ORIGINATION FORM

Proposed Revisions to a Standard Plans Index (Please provide all information — Incomplete forms will be returned)

Index Number: 522-002

Index Title: Detectable Warnings and Sidewalk Curbramps

SHEET
1 of 7

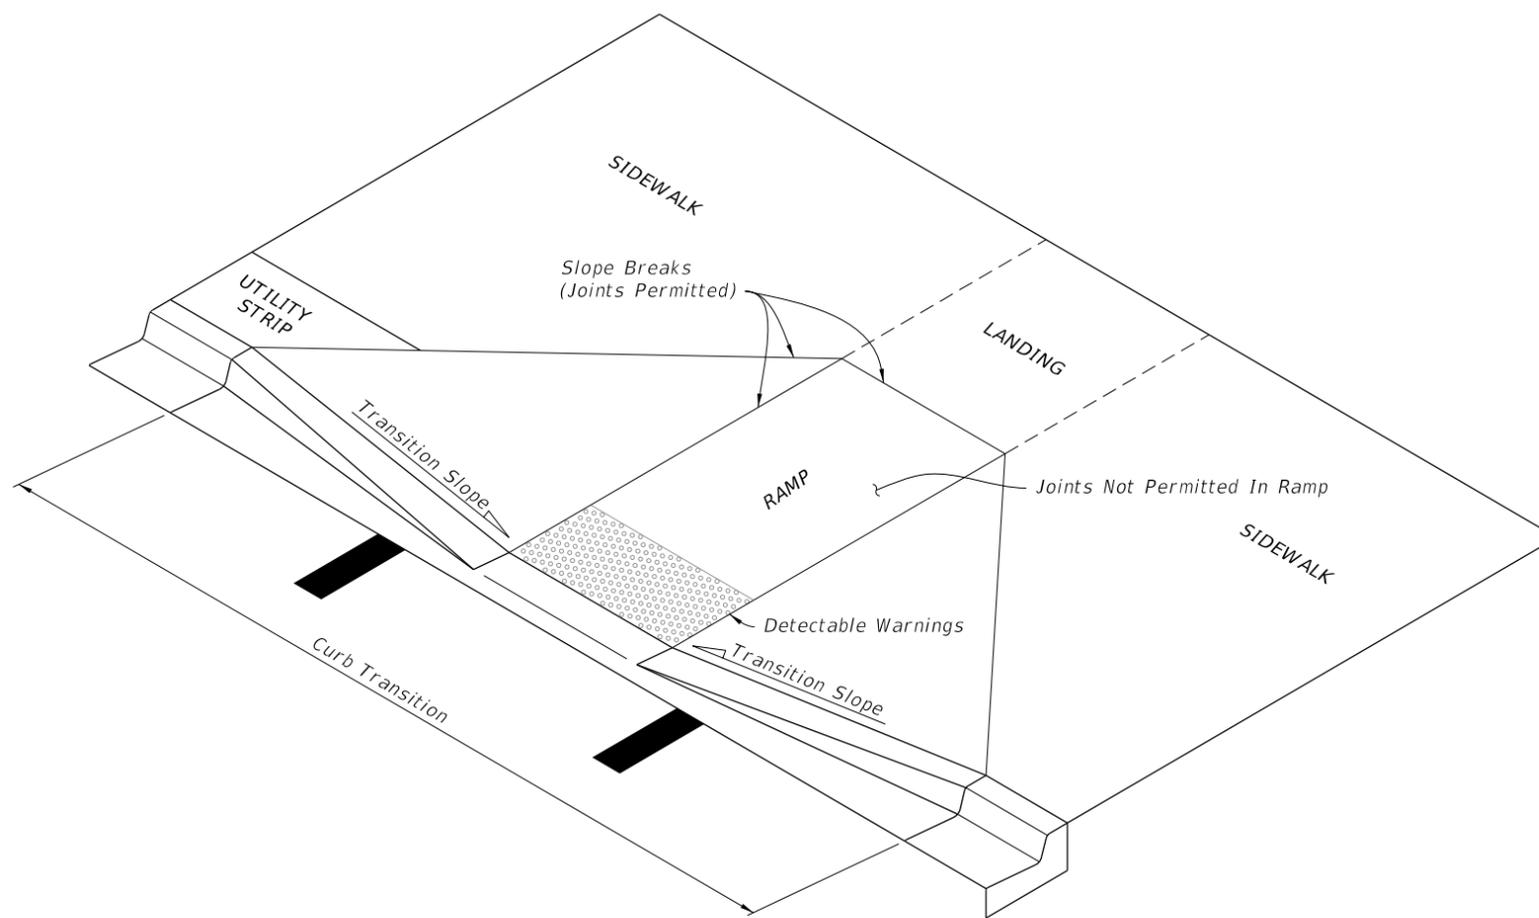
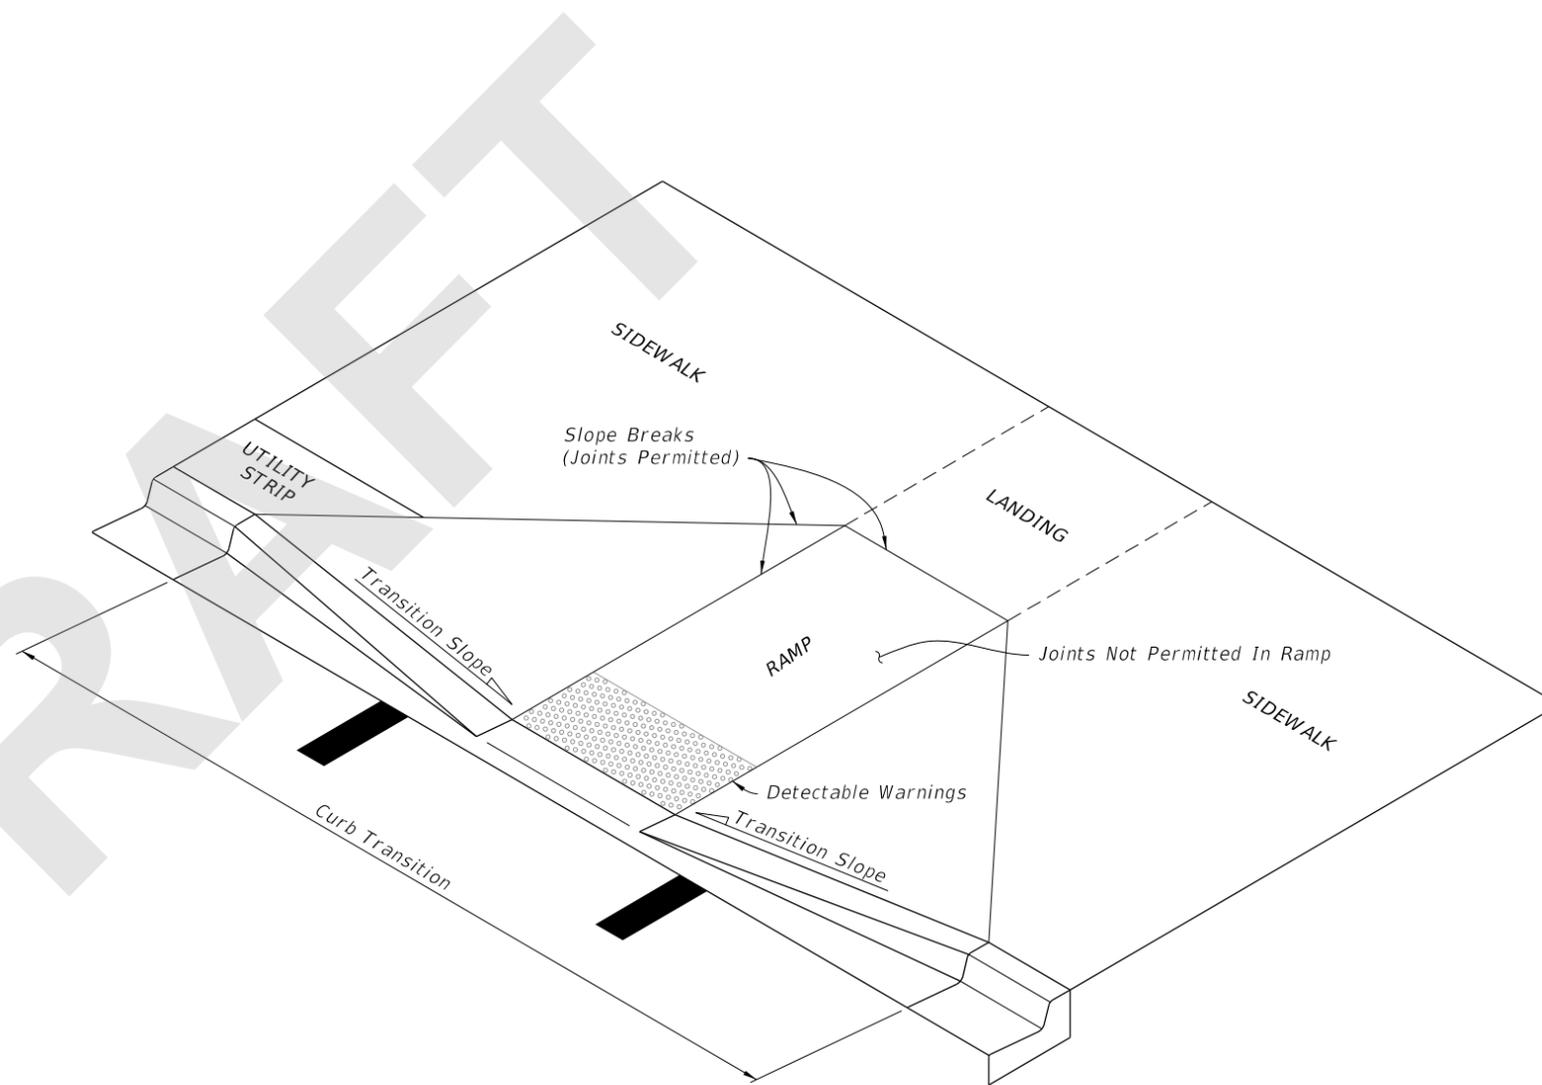
Sheet 1: Deleted General Notes #5: Detectable Warnings - Acceptance Criteria.

5. Detectable Warnings - Acceptance Criteria:

- A. Color and texture shall be complete and uniform.
- B. 90% of individual truncated domes shall be in accordance with the Americans with Disabilities Act Standards for Transportation Facilities, Section 705.
- C. There shall be no more than 4 non-compliant domes in any one square foot.
- D. Non-compliant domes shall not be adjacent to other non-compliant domes.
- E. Surfaces shall not deviate more than 0.10" from a true plane.

As long as the requirements of ADASTF 705 are a condition of being on the APL, there's no need for Note #5 in the SP. Note #5E is covered by the ADA standards and by the phrase, "securely installed even with the substrate" in our updated spec – meaning, there's no abrupt change in level at the edge of the dome mat.

SHEET
2 of 7

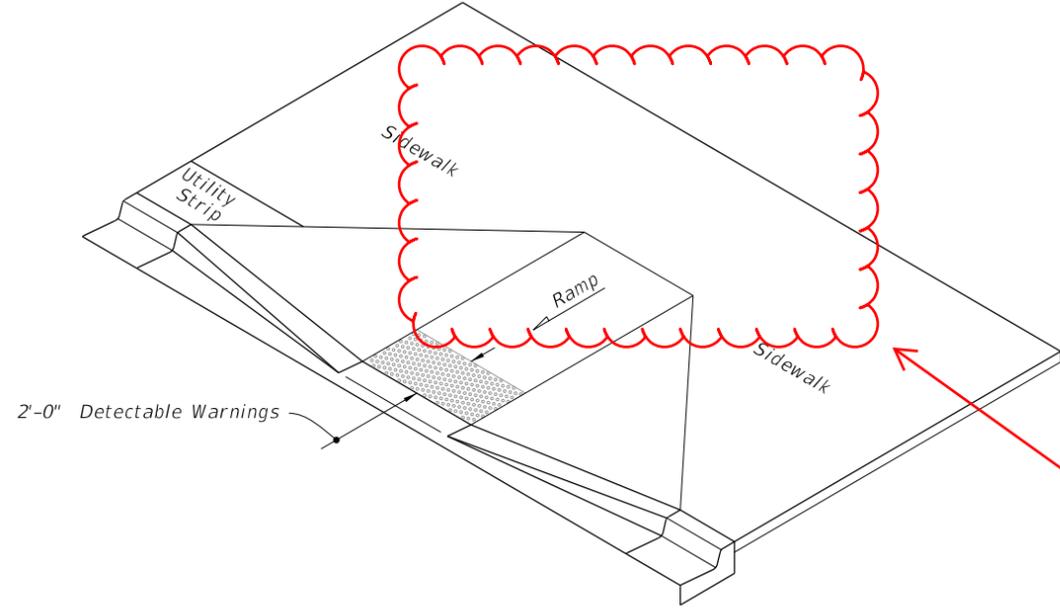
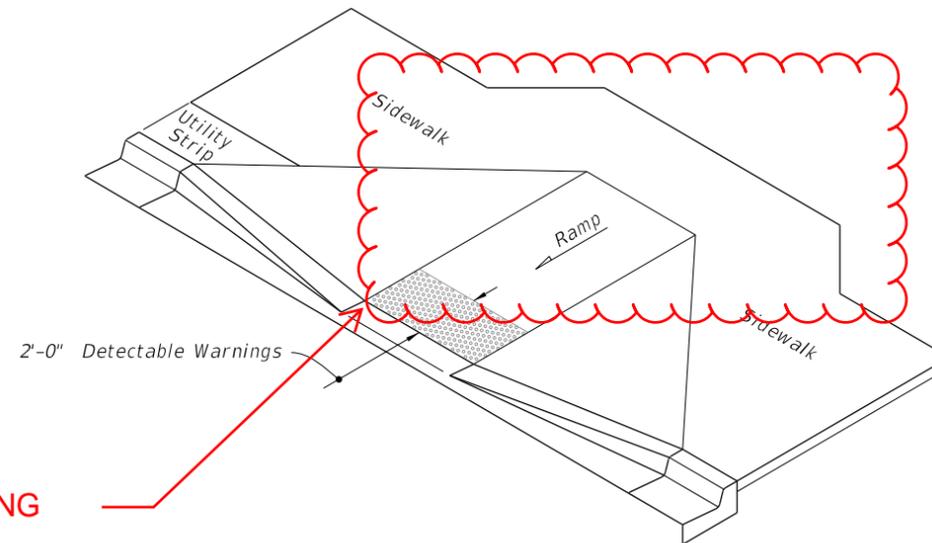
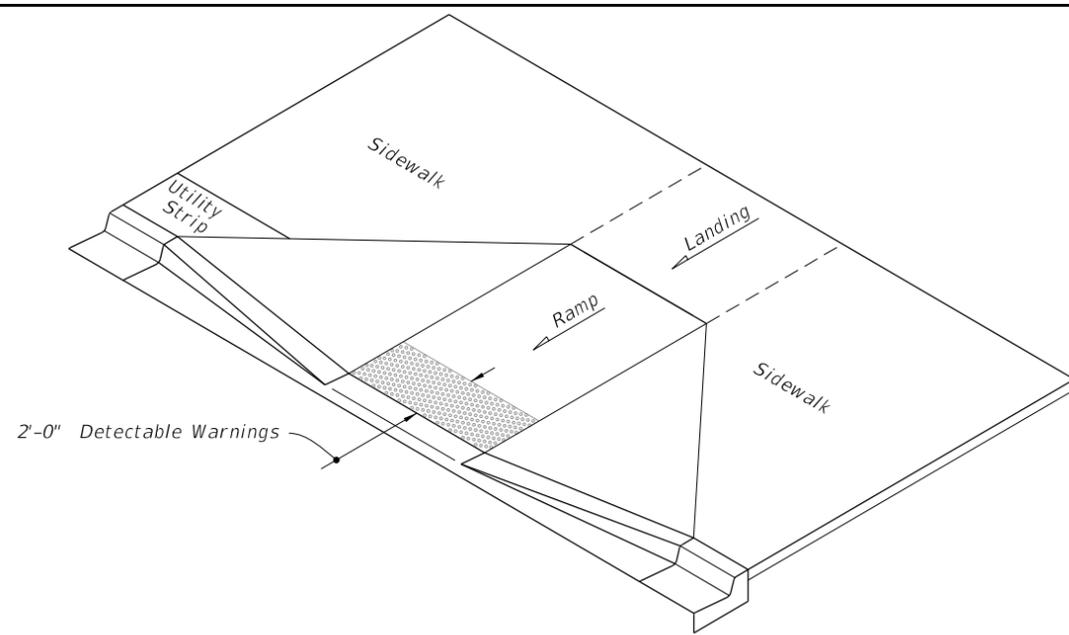
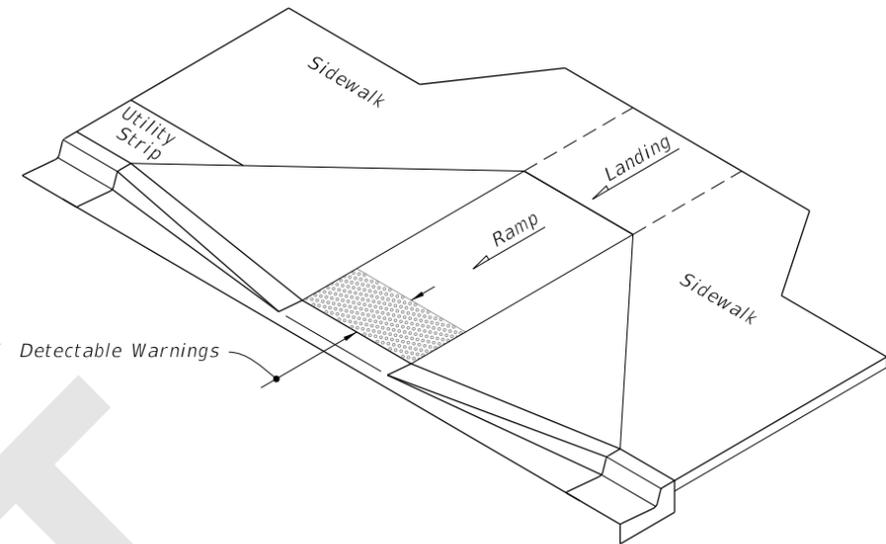
Sheet 2: Added Landing to isometric views

ADDED LANDING

SHEET
7 of 7

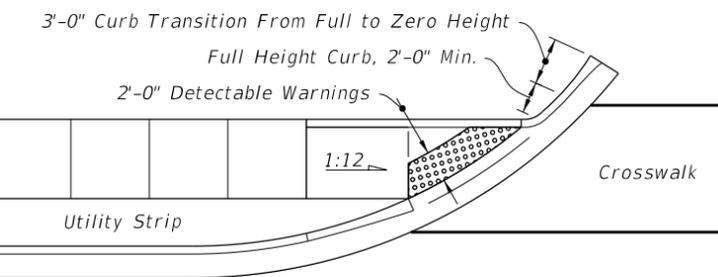
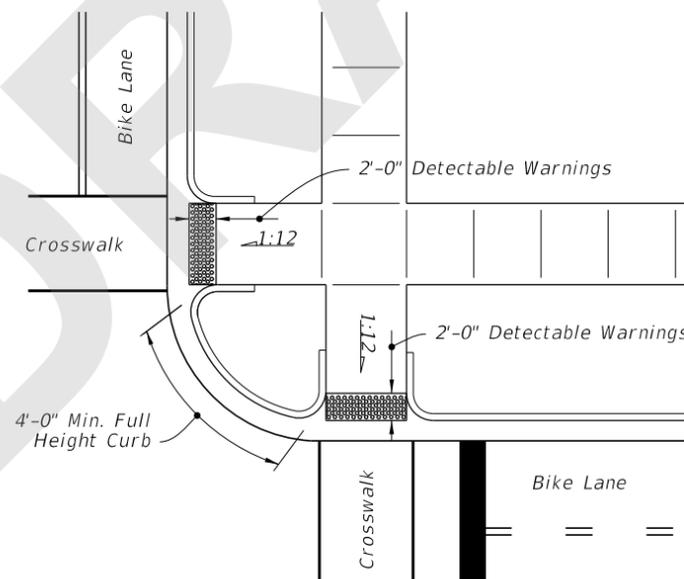
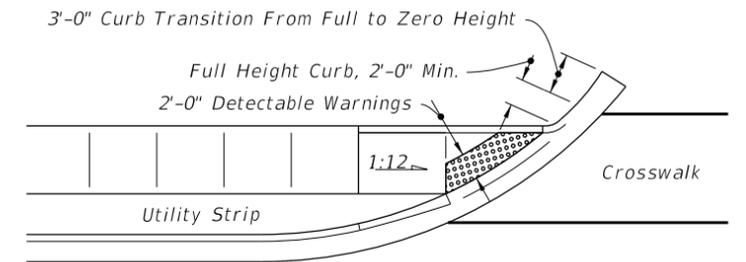
Sheet 7: Added New Detail "Curb Ramp Outside Radial Return"

ADDED NEW DETAIL
"CURB RAMP OUTSIDE RADIAL RETURN"
